DOCUMENT CHANGE REQUEST

DCR number 396	Changes required for: N/A	Originator: Samuel SAVIN
Date: 2008/02/28	Date sent: 2008/02/28	Organisation: CNES
Status: IMPLEMENTED

Title:	Diodes, Power Rectifier, High Efficiency Fast Recovery , based on Type BYV 54-200		
Number:	5103/031	Issue:	3

MARK-UP FOR DCR 396
S. Thacker
17/07/08.

NOTES:

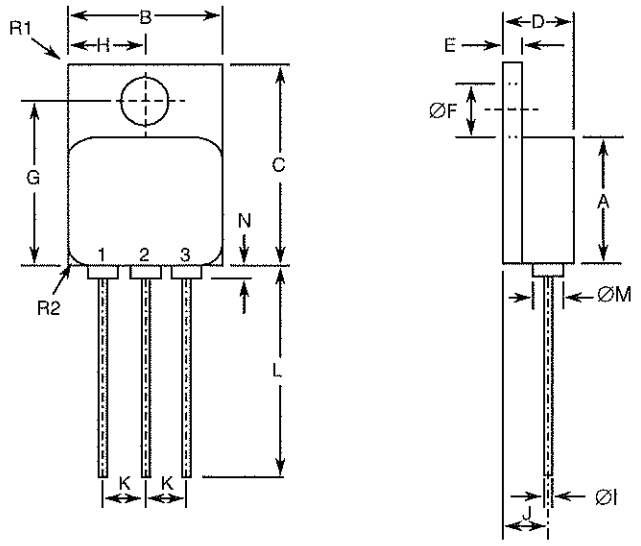
1. Sinusoidal pulse of 10ms duration.
2. Pulsed, duration 5ms, f = 50Hz.
3. ~~At T_{case} > +110°C, derate linearly to 0A at +150°C.~~ At T_{case} > +90°C, derate linearly to 0A at +150°C for Variants 01, 02, 03. At T_{case} > +99°C, derate linearly to 0A at +150°C for Variants 04, 05.
4. For Variants 01, 03, 05, with hot solder dip lead finish, all testing performed at T_{amb} > +125°C shall be carried out in a 100% inert atmosphere.
5. Duration 10 seconds maximum at a distance of not less than 1.5mm from the device body and the same lead shall not be resoldered until 3 minutes have elapsed.
6. Package mounted on an infinite heatsink.

Justification :
For variant 01 and 02
Calcul of the derating is wrong:
For max rating 40A we have used f max at 30A instead of 40A with I0 max at 30A.
The right calculation is:
for I0 max 40A, Vf max = 1.5V (issued from ST data characterization).
Formula applied:
Max power derating = Tj – (Io x Vf x Rth(j-c)) = 150 – (40 x 1.5 x 1) = 90°C

The new limit for the derating is 90°C

For variant 03 and 04
Max power derating = Tj – (Io x Vf x Rth(j-c)) = 150 – (40 x 1.26 x 1) = 99°C

Para 1.8

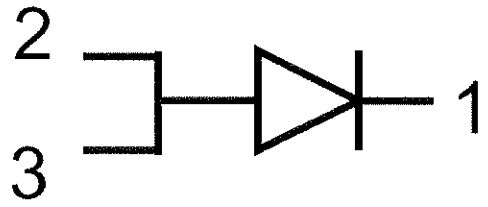
* Add new figure - see attached

Variants 04, 05

Terminal 1: Cathode
Terminal 2: Anode
Terminal 3: Anode

Variant 03 and 04

Terminal 1 : Cathode
Terminal 2 : Anode
Terminal 3 : Anode
